PLANNING COMMISSION MEETING

LOCATION: TOWNSHIP ANNEX, 7527 HIGHLAND ROAD, WHITE LAKE, MICHIGAN, 48383
(FORMER WHITE LAKE LIBRARY)
THURSDAY, JANUARY 06, 2022 – 7:00 PM

RE: Taco Bell Preliminary Site Plan Review – 1st Review

Subject: Taco Bell
Preliminary Site Plan Review #2
Zoned: Planned Business (PB) District

A4.0

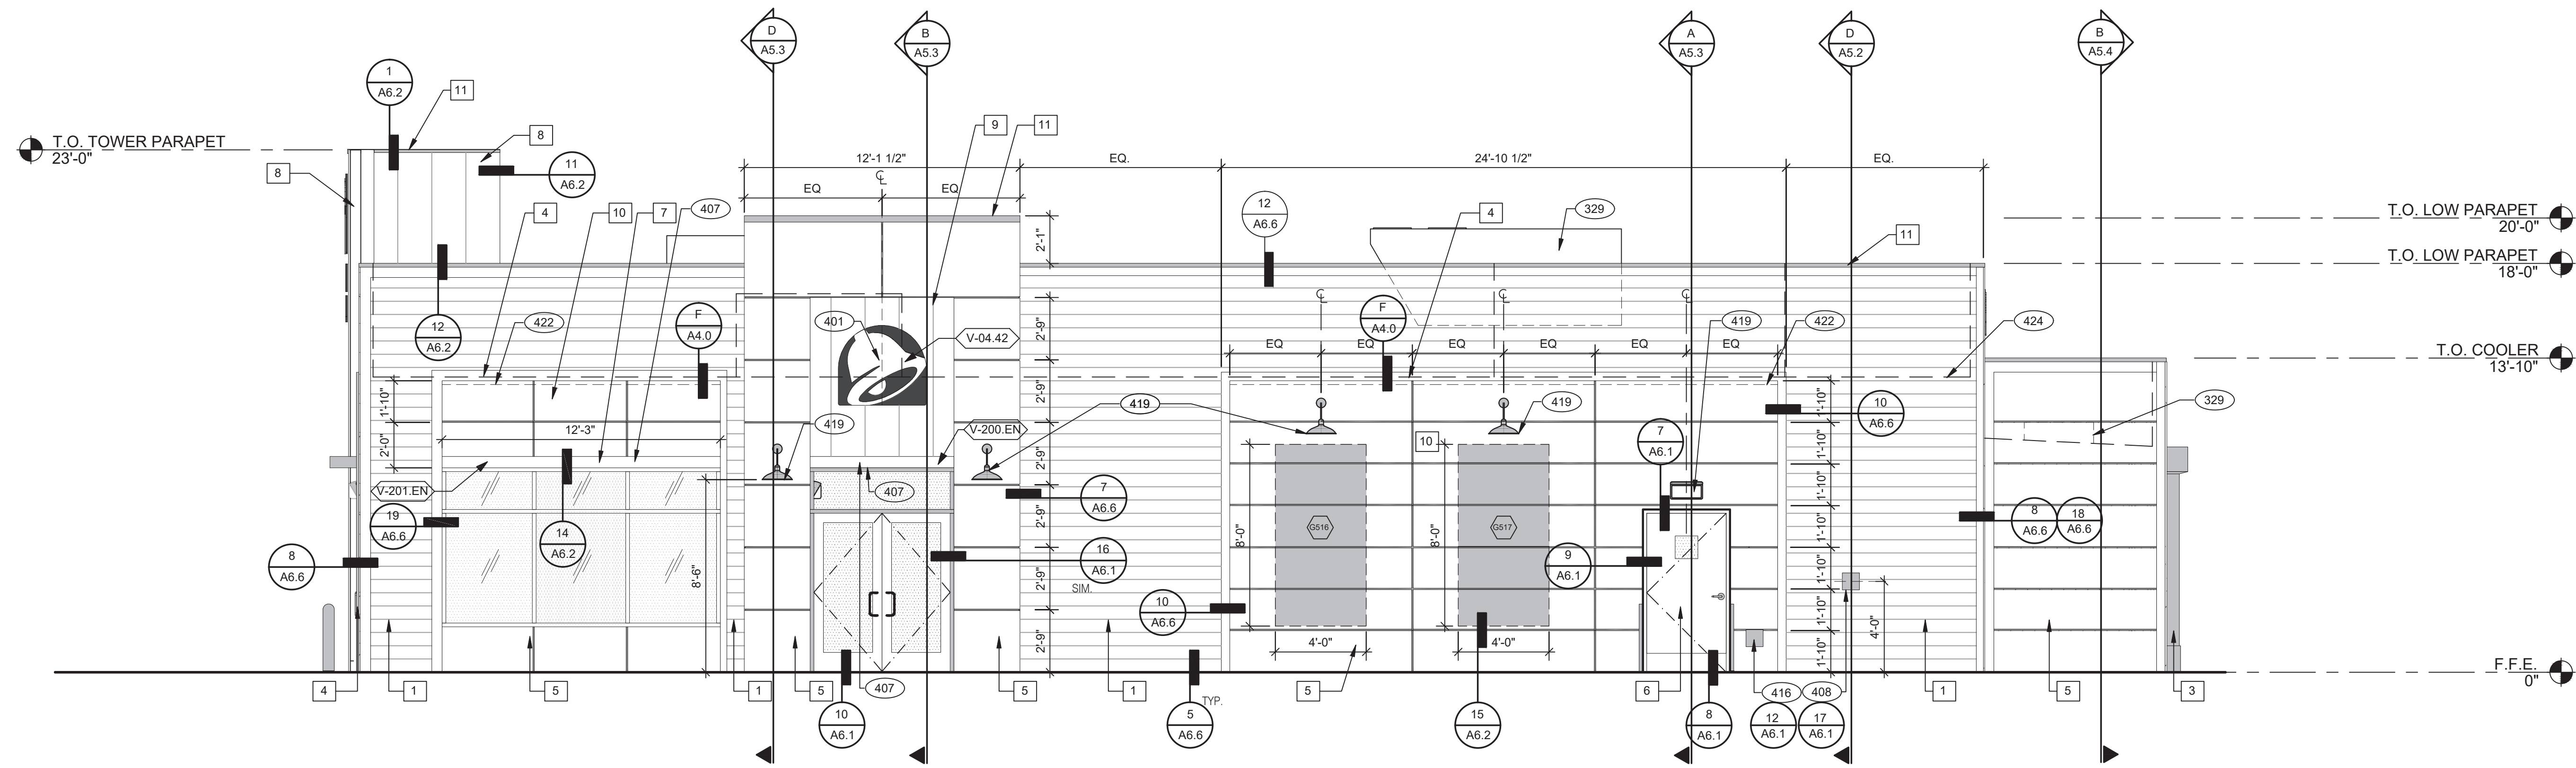
The bulk of the exterior consists of gray Hardie plank siding (although on the elevations, it appears beige, the specifications indicate that it is a gray color). A “corner tower” is located on the southwest corner of the building and consists of 18” wide painted panels with the appearance of a rusted metal. Above each bank of windows, is a purple Hardie reveal panel. A black metal Hardie trim board “outlines the purple panels, and top and corners of the building. On the east elevation, black Hardie panels frame the entrance as well as the murals and the wall signage. The west elevation also consists of the gray Hardie plank and purple and black panels interspersed on the façade. The cooler and freezer are located in the rear of the restaurant and are contained in a projection that extends 8’ from the rear façade and is 21’-9 ½” in length and 13’ in height. The rear elevation consists of the gray Hardie plank siding on the rear wall and black Hardie panels on the cooler and freezer projection.

- b. **Building should address the street with entrances, windows, and architectural features facing the street. No overhead doors shall face the street, unless approved by the Planning Commission based upon a finding that the door is recessed back from the front facade and properly screened from public view.** The primary entrance is on the east elevation although there is an entrance door on the Highland Road frontage. The west (Bogie Lake Road) elevation only has the drive thru windows and two small windows adjacent to the corner tower. The petitioner needs to address this also.

- c. **Buildings should be designed with varied architectural details to provide visual interest.** The building does have varied architectural details, albeit of (primarily) inferior materials.

- d. **All buildings shall have windows at eye level. Windows should cover at least thirty (30%) percent of the front facade. Reflective glass may be permitted for office uses but shall not be used for retail stores. The windows shall not be obscured at any time, except by signage as permitted in Section 5.9.** This requirement appears to have been met partially, although the petitioner needs to provide calculations on the final site plan. The west (Bogie Lake Road) elevation should have more windows to meet the spirit of this requirement.

UTILITY PLAN
 SCALE: 1" = 20'

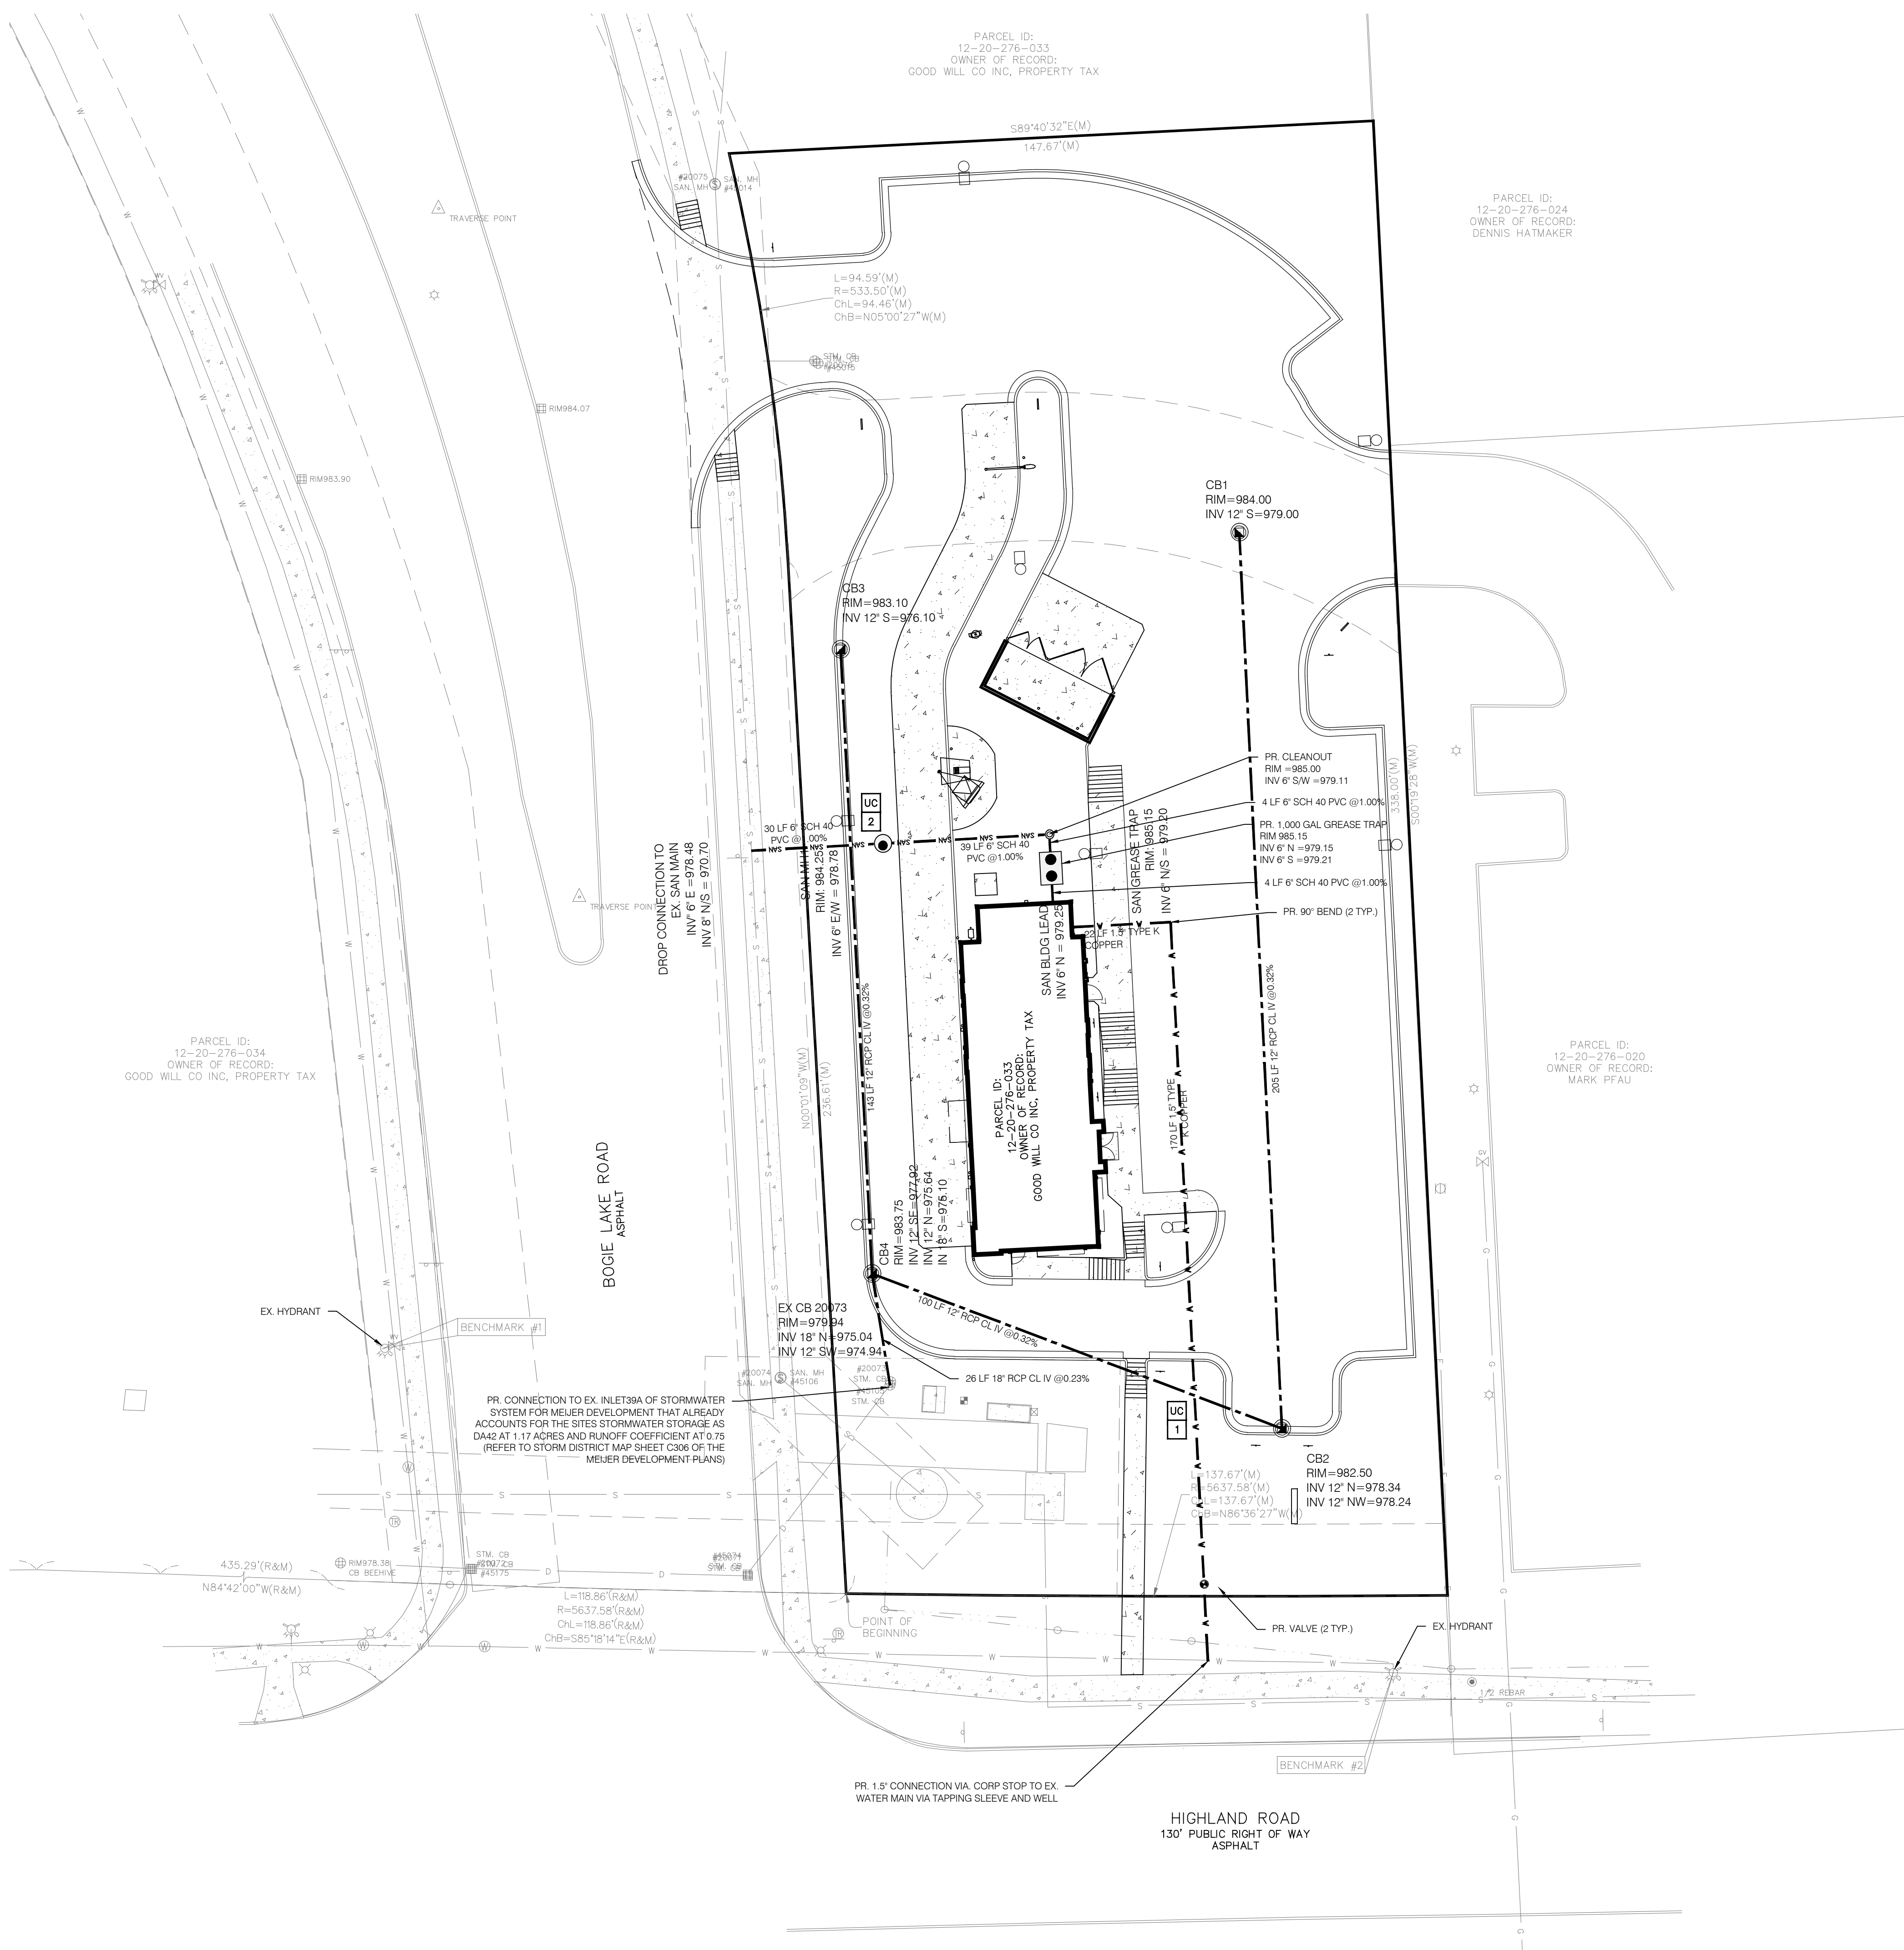
1. We defer to the Fire Department with regard to any items related to fire suppression including hydrant spacing. Note there is an existing fire hydrant near the south east corner of the subject property.
2. Plans show a 1.5" copper service lead for the building which satisfies the level of detail required for this submittal. The plans indicate the service tap will be made via tapping sleeve and well; please note that a well is not required for the service lead connection.

1. A proposed 6" sanitary sewer lead has been indicated along with a 1000-gallon grease trap meeting the level of detail required for this level of submittal. Please note that the wastewater flowing through the grease trap shall only come from the kitchen, an additional lead for black water shall come from the building and connect to the proposed sewer lead downstream of the grease trap.

1. Many of the existing utility structures are double labeled making them difficult to read and identify, please review and revise as necessary.
2. Please show existing off site storm sewer to clarify ultimate stormwater discharge point. Plans reference the Meijer plans and subject property being part of the Meijer drainage district, however, existing storm sewer shown on the plans does not appear to connect to the Meijer storm system.
3. Please clarify if stormwater treatment will be accomplished within the existing Meijer detention system or if pre-treatment will be required prior to stormwater leaving the site.

4. The plan shows a proposed connection of an 18" diameter storm pipe to the existing 12" diameter storm sewer. We question the basis for this design and note that the intent on the site shall not be to restrict storm water flows which would result in parking lot detention. Please clarify.

Note 11 on sheet C5.0 indicates that the Township shall connect services 2 inch and smaller. While the Township can provide the connection, an 20 % admin fee will be charged per ordinance. It will usually be less expensive for the developer to use their own properly licensed and bonded contractor for the connection which we will inspect.
